Submittal No.: 03c: Containment Plan for 9 Bridges, R1, SS

Description: Proposal/Contract Number: Windsor-Hartford IM BPNT (13)
Letting Date: 10/09/15; Award Date: 11/02/15
Project Description: Bridge Painting of Eleven Bridges
In the Towns of Windsor & Hartford, Windsor County, VT
Contract Amount: \$8,671,323.00; Completion Date: 10/12/18

Containment Plan For 9 Bridges

ABRASIVE BLASTING CONTAINMENT PLANS, REV. 1

BRIDGE NO. 41C

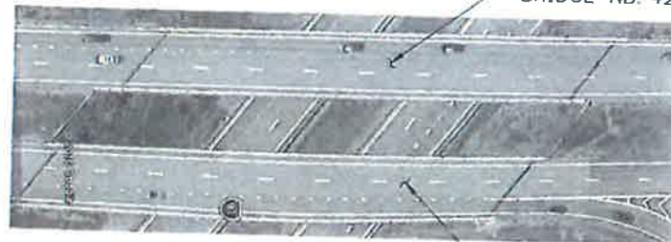
FOR CONTAINMENT PLANS SEE SHEETS C-20 THRU ~~C-22~~

FOR CONTAINMENT PLANS SEE SHEETS ~~C-28~~ THRU ~~C-30~~

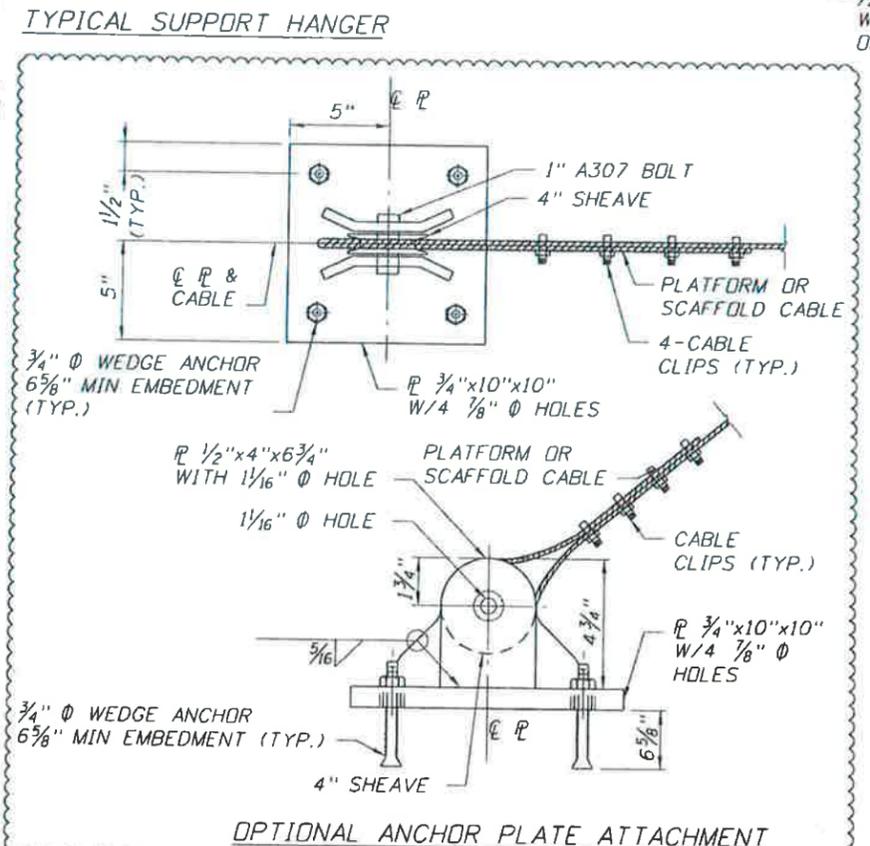
PB AMERICAS, INC.
 HOOK HANGERS MAY NOT CAUSE DAMAGE TO STEEL SURFACES
